PCN: V18-003-F48070-MA

Product Change Notice

Issue Date: 25 July 2018

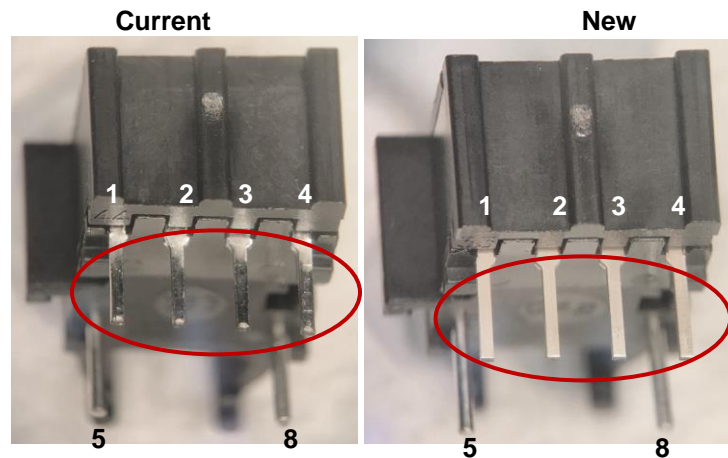
Qualify NiPdAu pre-plated lead-frame.

Active pins (pin1 to pin4 in red circle): Affected by changing to new NiPdAu lead-frame finish.

Housing staple pins (pin5 and pin8): No Change.

Eliminate additional solder dip process by implementing NiPdAu Pre-plated lead-frame to improve product reliability, product cycle time and to simplify lead-frame supply chain. The NiPdAu pre-plated lead-frame has been qualified and used in other Broadcom industrial products since year 2015. Lead frame layout and base material remain unchanged.
